HIGH PLAINS FILING NO. 1

CONSTRUCTION DOCUMENTS

SP-18-003
SF-18-024

HIGH PLAINS FILING NO. 1
GRADING & EROSION CONTROL PLAN

SIGNAGE & STRIPING PLAN

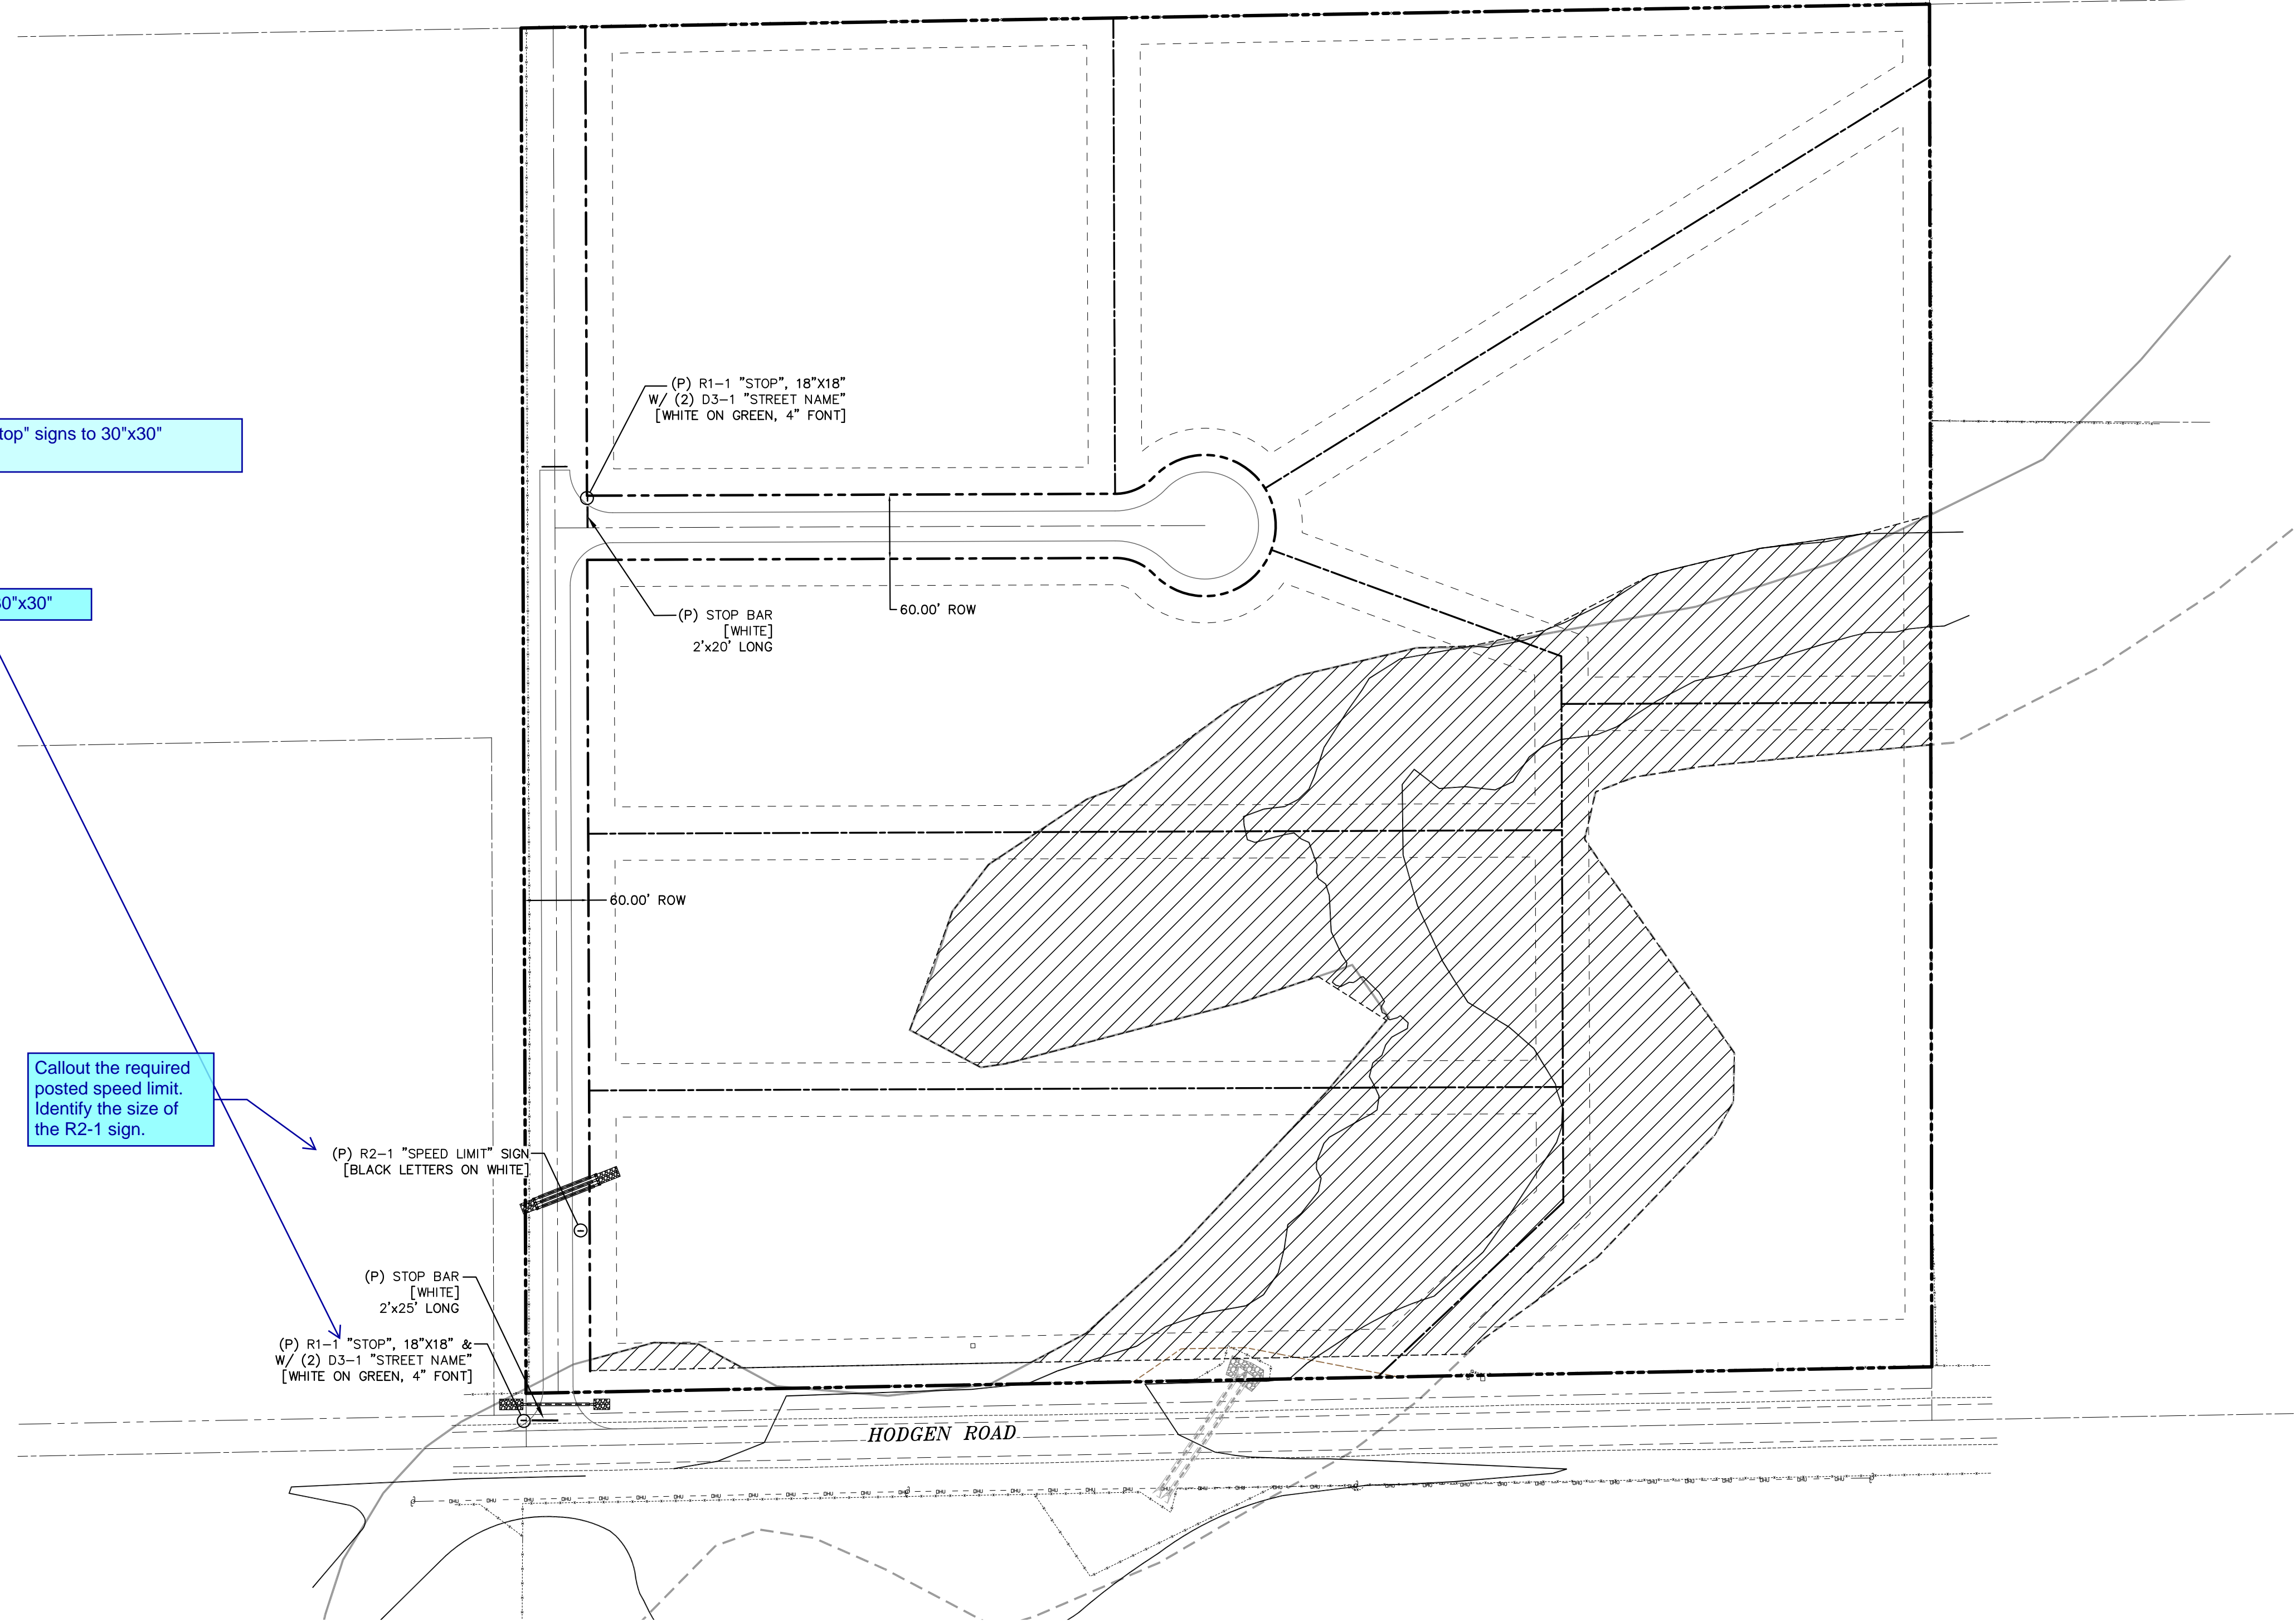
Revise "Stop" signs to 30"x30"

Revise to 30"x30"

Callout the required posted speed limit. Identify the size of the R2-1 sign.
